# P802.1CQ Discussion 2019-11-13

Roger Marks (EthAirNet Associates) Antonio de la Oliva (Interdigital)

2019-11-13

## **Updated PALMA flowcharts**

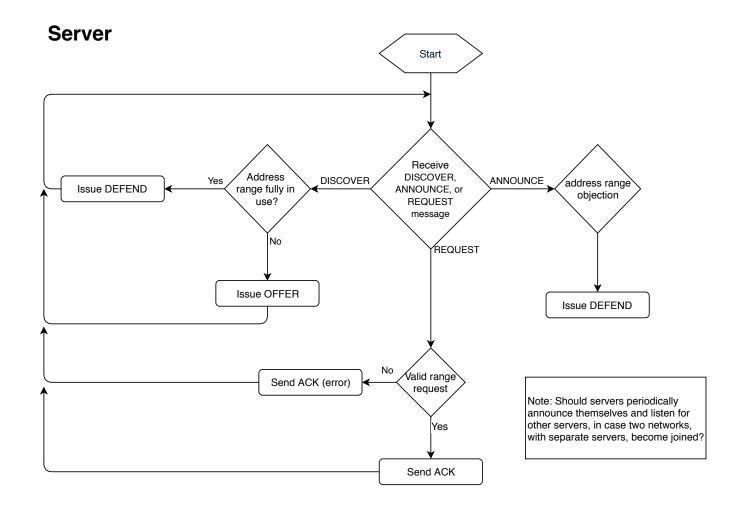
My client flow diagram included a text box to cover the case of a server outage. It said: "Clients with server-assigned address need not send periodic multicast ANNOUNCE messages, since the server can handle the defense. Should client with server-assigned address send period unicast message to server to confirm that server is still active?"

- (a) The server-assigned client would listen for DISCOVER messages.
- (b) When the server issues a DEFEND, it uses multicast.
- (c) If the server-assigned client hears a DISCOVER that needs to be defended, then it listens for the multicast DEFEND from the server.
- (d) If it does not hear that multicast DEFEND, then it issues its own unicast DEFEND.

This saves unicast traffic, but it adds multicast traffic; maybe a lot of it. On the prior call, Norm expressed a concern with the extra multicast when all the clients need to listen for DISCOVER (even though many, or even all, of them may have server-assigned addresses).

(1) Self-assigned addresses and server assigned addresses will be restricted by the standard to disjoint address blocks.

(2) Server-assigned addresses therefore need no defense since only a server can assign them. Clients with server-assigned addresses need not listen for DISCOVER messages (or send ANNOUNCE messages). They are not part of the claiming process at all. If a server goes down, all of the existing server assignments operate normally.
